NEW FIRE SERVICE LATERAL AND VAULT

TO BE CONSTRUCTED FOR NEW FIRE SUPPRESSION SYSTEM FOR KAZIM TEMPLE CORP.

> SITUATE 628 CAMPBELL AVENUE, SW CITY OF ROANOKE, VIRGINIA

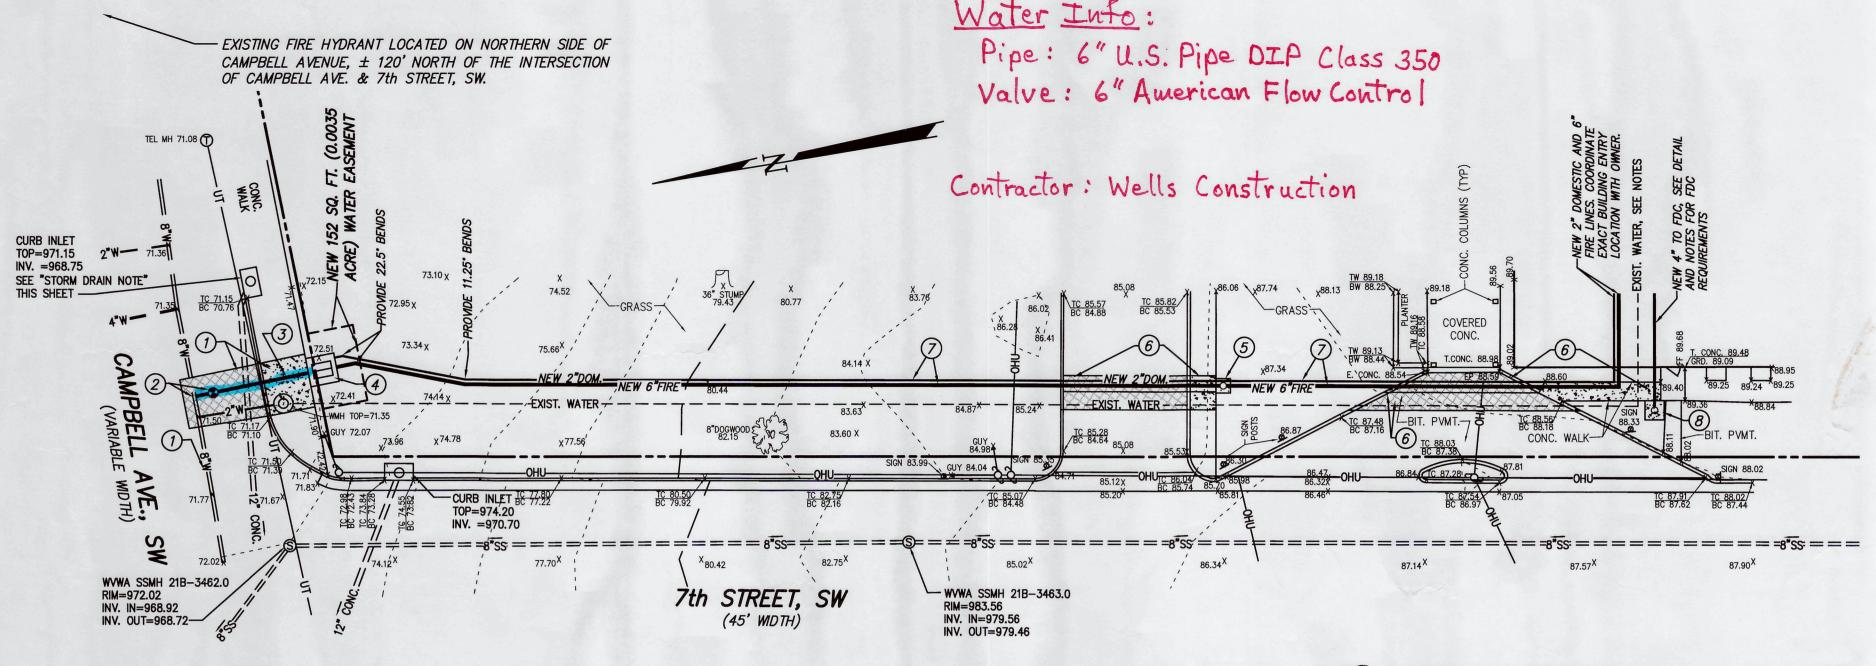
Existing 2" service was cut downstream of the corp stop at the main, and the corp stop was turned off. Existing 2" service line was abandoned in ground and existing meter vault was abandoned WATER OR GAS METER in ground. FIRE HYDRANT MANHOLE CLEANOUT DROP INLET (CURB OR GRATE)
